# SAFETY RECALL

## 2nd Row Child Tether Anchor Weld

Reference: 85B / NHTSA 24V-586

Remedy available for  
2024 (WL) Jeep Grand Cherokee L

**Figure 3 – Installing Rivets to Child Tether Anchor**

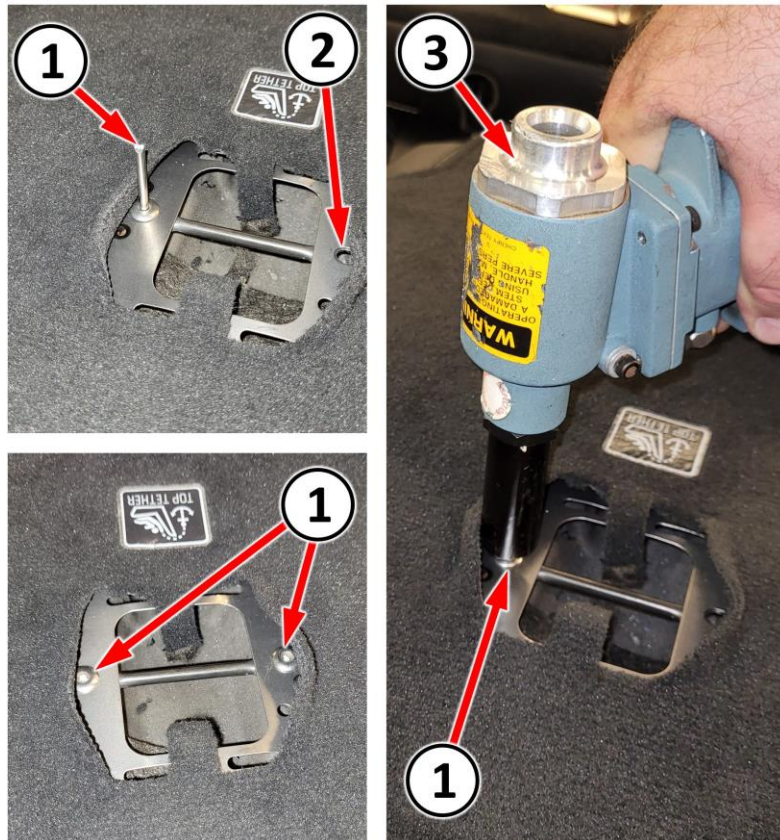
4. Insert one rivet in each pre-existing hole on either end of the child tether anchor (Figure 3).
5. Using an appropriate rivet gun, secure both rivets (Figure 3).

Install rivets to reinforce the existing child tether anchor structure on the left-side 2<sup>nd</sup> row seat back frame.
